UNITED STATES
NUCLEAR REGULATORY COMMISSION
WASHINGTON, D. C. 20555

AMENDMENT TO FACILITY OPERATING LICENSE

Amendment No. 106
License No. DPR-46

SAFETY EVALUATION BY THE OFFICE OF NUCLEAR REACTOR REGULATION
SUPPORTING AMENDMENT NO. 106 TO FACILITY OPERATING LICENSE NO. DPR-46
NEBRASKA PUBLIC POWER DISTRICT
COOPER NUCLEAR STATION
DOCKET NO. 50-298

Figure 3.11-2e P8 x 8R & BP8 x 8R Fuel
(BOC to EOC-1000 MWd/ST)

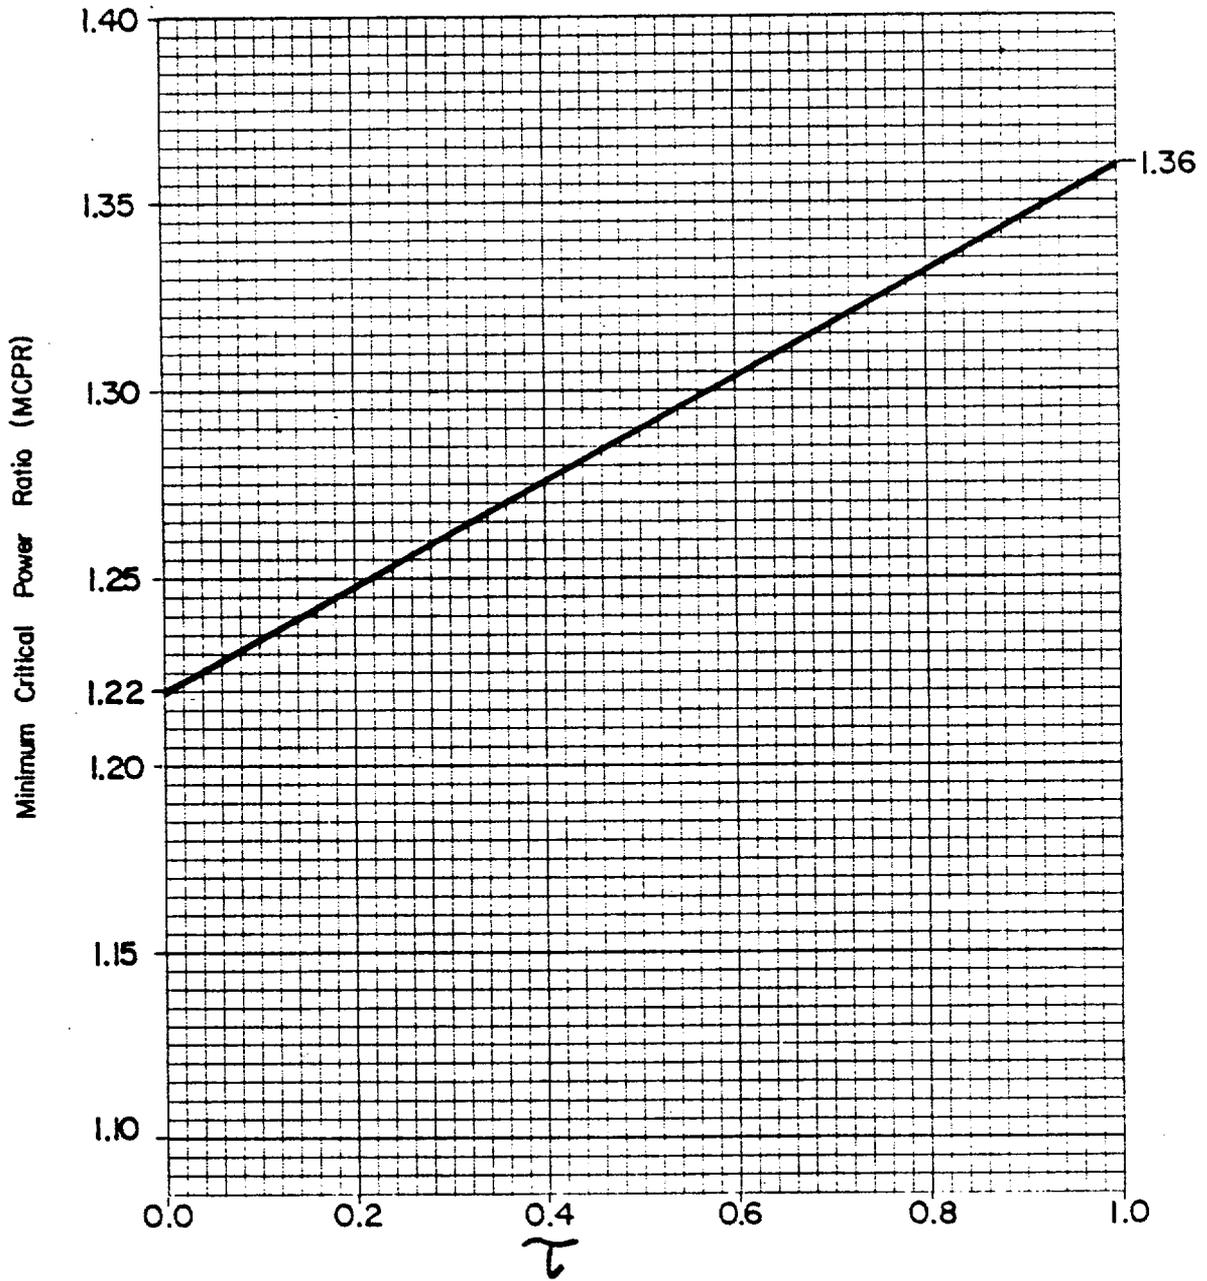
The most limiting events have been analyzed by the licensee to determine which event could potentially induce the largest reduction (Δ CPR) in the initial critical power ratio. The Δ CPR values given in Section 10 Reference 2 are plant specific values calculated by the approved methods including ODYN methods. The calculated Δ CPRs are adjusted to reflect the calculational uncertainties by employing the conversion methods described in Reference 7. The operating limit MCPR (OLMCPR) values are determined by adding the adjusted Δ CPRs to the safety limit MCPR. Section 12 of Reference 2 presents the Cycle 11 MCPR values of both the pressurization and non-pressurization transients. The maximum MCPR value in Section 12 is the operating limit MCPR for the cycle and must be bounded by the technical specification (TS). The value of operating limit MCPR is determined by the limiting transients, Rod Withdrawal Error (RWE), Feedwater Controller Failure (FWCF) and Load Rejection Without Bypass (LRWBP). The analysis of these events for CNS, via the ODYN Option B approach, provide new Cycle 11 technical specification values of OLMCPR as a function of average scram time, τ . The proposed Cycle 11 TS change for OLMCPR is given in Figure 3.11-2e for BOC to EOC -1000 Mwd/ST. That is linear as OLMCPR = .14 τ + 1.22, however, the Cycle 10 TS is

- A. Page 210 (Limiting Condition for Operation - Average Planar Linear Heat Generation Rate) - The specification would be revised to include BP8x8R fuel among the types of fuel for which the APLHGR reduction factor applies.
- B. Page 212f - Figure 3.11-2e - Minimum Critical Power Ratio (MCPR) vs Tau (based on tested measured scram time as defined in Reference 8) for P8x8R and BP8x8R Fuel (BOC to EOC - 1000 Mwd/ST). This figure is the result of new analyses.
- C. Page 214b - Reference No. 9 (Reference 8) to be added to the bases of Section 3.11 which was inadvertently deleted by Amendment No. 94.
- D. Page 217 - (Major Design Features - Reactor) - The description would be revised to indicate that BP8x8R fuel is used.

2.7.2 MCPR Specification Format - Figure 3.11-2e

P8x8R and BP8x8R Fuel BOC to EOC - 1000 Mwd/ST vs τ : The cycle Minimum Critical Power Ratio (MCPR) as a function of the parameter τ is presented in curve form. This curve is changed to reflect the new transient analyses as previously discussed. The change is acceptable.

$$\begin{aligned} \text{OLMCPR} &= 1.22 \text{ when } \tau \leq .38 \\ &.225 (\tau - .38) + 1.22 \text{ when } \tau \geq .38 \end{aligned}$$

therefore, the proposed Cycle 11 TS based on the analysis for the new fuels bounds the Cycle 10 TS values, and is acceptable.
